# EXHIBIT A

## STAFF REPORT

SUBJECT: H-2020-0032

Brody Square

A. Preliminary Plat (date: 7/1/2020)

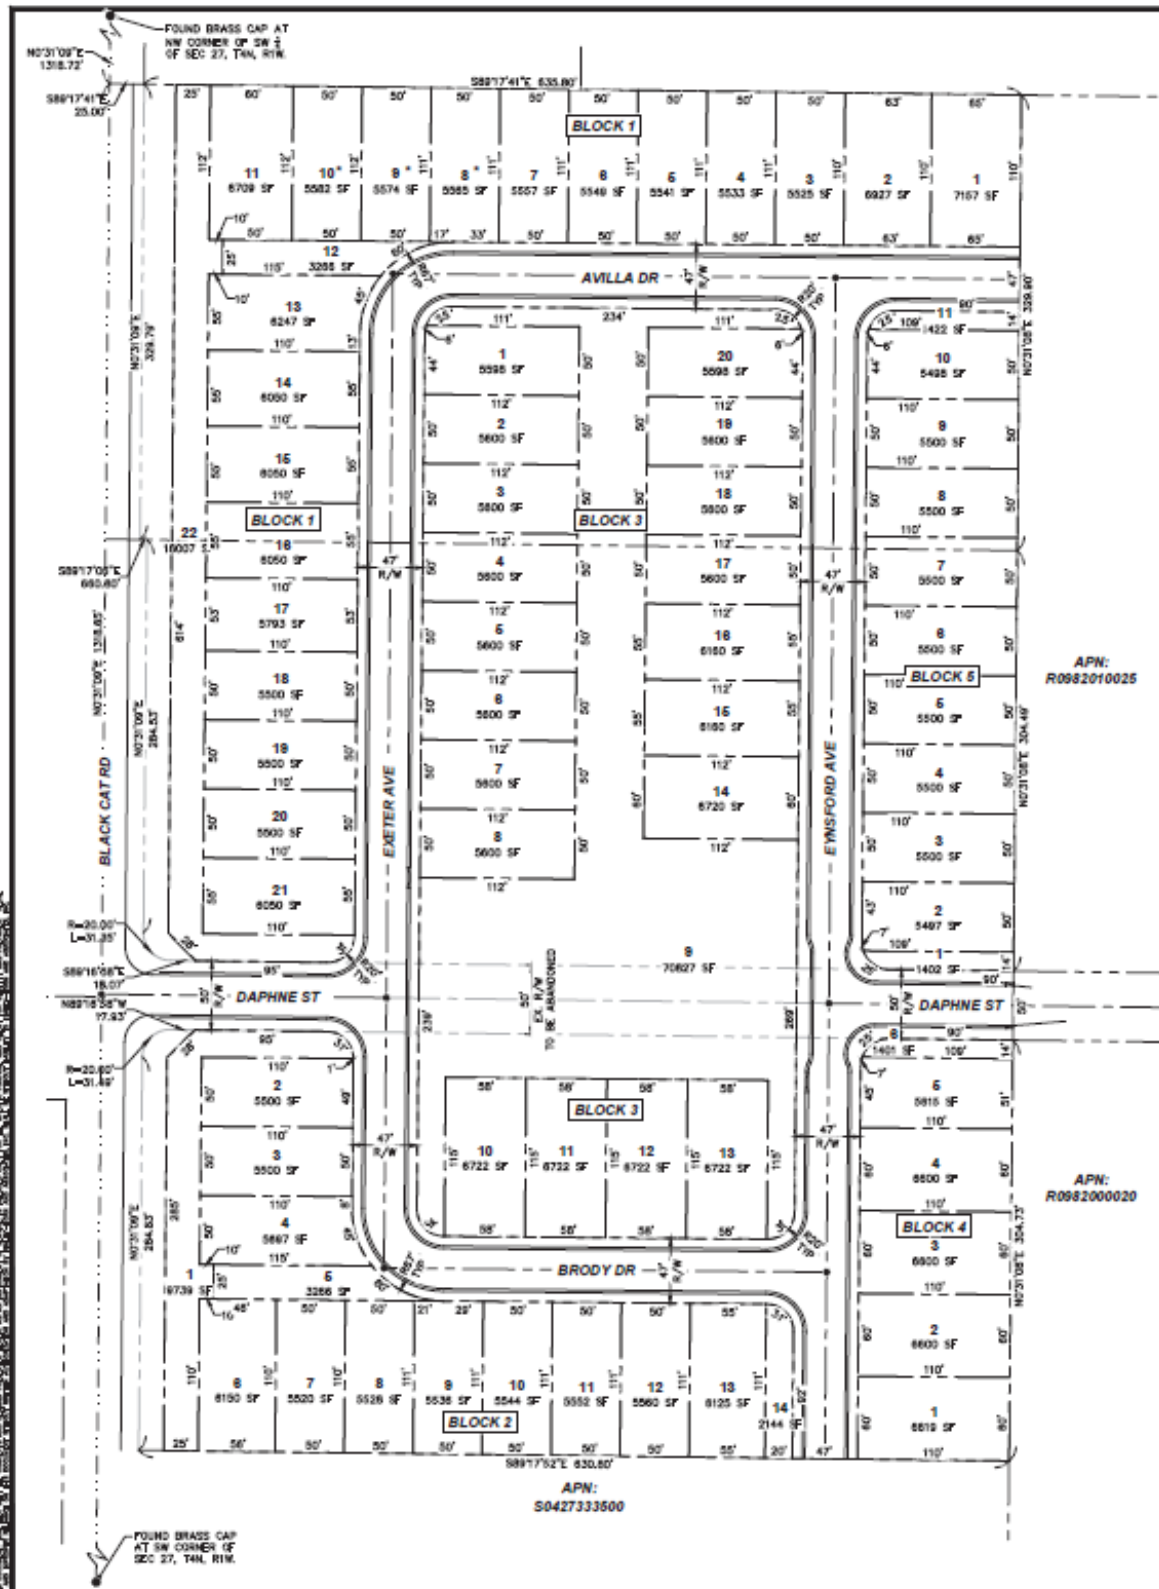
*During the November 7, 2019 Pre-Application Meeting, staff recommended that a stub street should be provided to the north from Avilla Drive through Block 1. This is to allow future access from the property at 5230 N. Black Cat Rd if it were to redevelop in the future. This access is not provided. Staff is recommending this as a condition of approval.*

- a. Remove staff condition for a stub street to be provided to the north from Avilla Drive through Block 1.
  - b. Remove Lot 61 to reconfigure the pond into this area to provide a better open space and allow the connection of the pathways as recommended by staff.

5. Outstanding issues(s) for City Council:
- a. The lot numbering on the plat versus the landscape plan is not consistent. The plat has the correct numbering. The Planning Commission recommendation for homes on Lots 42-44 to be limited to one-story should be changed to Lots 8-10, Block 1.

2. This approval is based upon ACHD vacating the requested section of Daphne St.
  3. The plat included in Section VII, dated 7/1/2020, shall be revised as follows prior to submittal of the final plat application:

- i. ~~A stub street shall be provided to the north from Avilla Drive through Block 1. This is to allow future access from the property at 5230 N. Black Cat Rd if it were to redevelop in the future.~~

B. Landscape Plan (date: 7/1/2020)

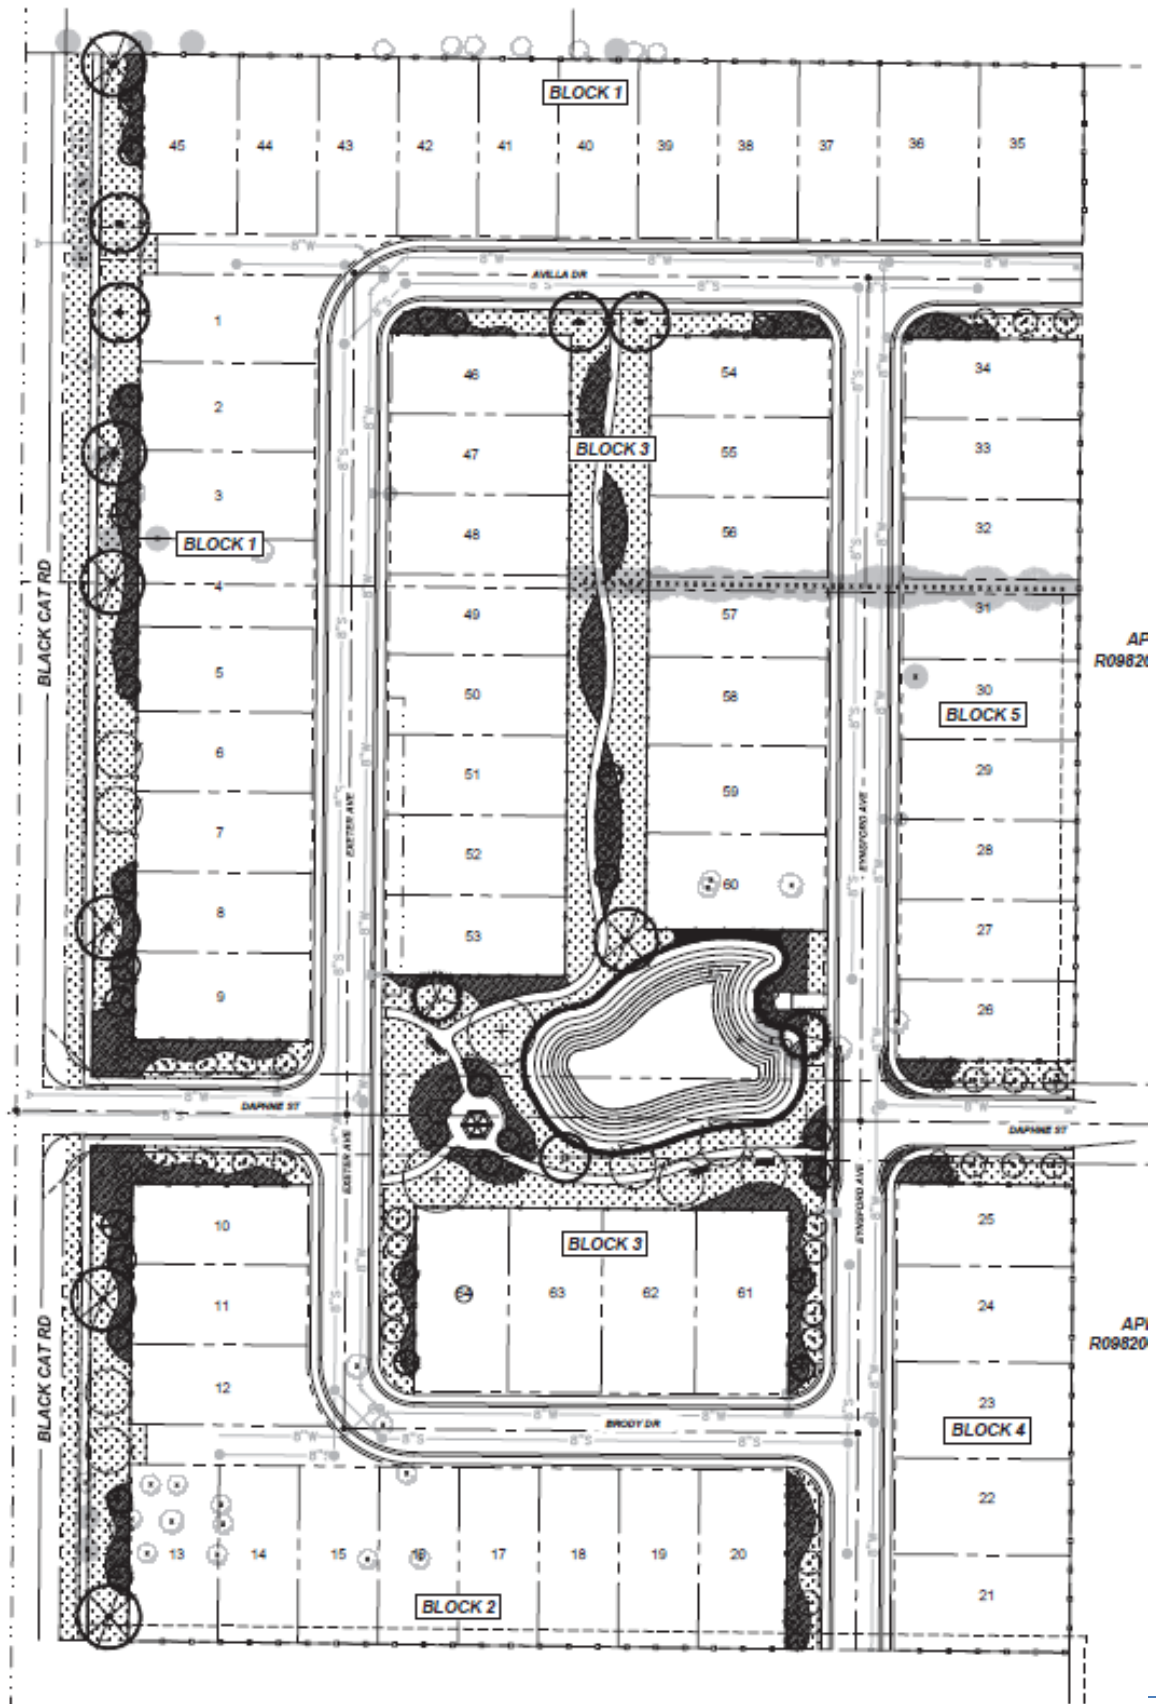
*The central park amenity shown in Lot 9 consists of a small pond, a gazebo and several pathways. At present, the pond cuts off walkway access in the middle of Block 3. It is staff’s opinion that connecting the two pathways along the pond would result in more useable space. Staff has added this as a recommended condition of approval.*

*The applicant is requesting an open water pond be credited toward their qualifying open space (as is discussed below). For full credit, staff recommends the northern and southern pathways connect along the pond to produce a more inviting and useable area.*

All fencing is required to comply with the standards listed in UDC 11-3A-6C and 11-3A-7. Fencing is shown on the landscape plan and consists of 6' high solid vinyl fencing around the entire perimeter of the development (including along Black Cat Road, and 5' open style lattice top fencing along the common areas. *There are several areas within Lot 9 (the common area) where closed style fencing is shown. UDC 11-3A-7 requires any fencing abutting pathways and open space to be open style.*

4. The landscape plan included in Section VII.C, dated ~~2/2/2020~~ 7/1/2020, shall be revised as follows prior to submittal of the final plat application:

- a. ~~The northern and southern pathways shall connect at the pond to result in a continuous pathway along the pond.~~
    - b. ~~Sitting and passive recreation areas shall be depicted on the landscape plan.~~

- c. The fencing shown in Block 3 shall be revised to be open style as required per UDC 11-3A-7.
  5. The applicant will submit a tree mitigation plan at time of final plat. This mitigation plan shall indicate the total number and caliper inches of trees proposed for removal and the total number of replacement trees proposed.
